# Access Compliance Report

## Public Rights-of-Way

### (Pedestrian Signals)

Intersection ID: N/A	Main Street:	Cross Street: N/A	Location: N/A
ADA ID: 00217DFFAA74	Signal Type: One Push Button-Non APS	Overall Compliance: No	Severity Score: BTN 1: N/A BTN 2: N/A No BTN: N/A
Codes/Mitigation Info/Possible Solution		Field Measurements/Component Compliance

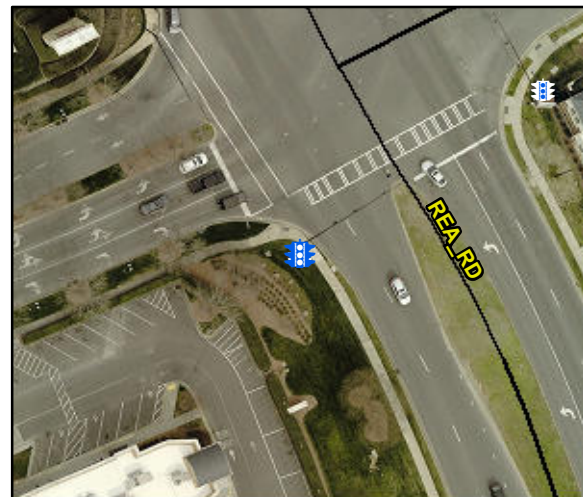
PROW/ADA: R410.6, TMUTCD 4e.08, R404.3, R404.1, R404.7.1, R404.7.2

Yes	B 1 Clear Xing Direction?	ClearlyMarked	N/A	B 2 Clear Xing Direction?	N/A
	B 1 Crossing Direction	To NE		B 2 Crossing Direction	N/A
No	B 1 DistanceTo XWalk (in)	176.0	N/A	B 2 DistanceTo XWalk (in)	N/A
No	B 1 DistanceTo Curb (in)	158.0	N/A	B 2 DistanceTo Curb (in)	N/A
Yes	B 1 Diameter (in)	2.0	N/A	B 2 Diameter (in)	N/A

Possible Solutions: Replace Signal Push Button With APS Button on New Post. Remove & Replace Sign.
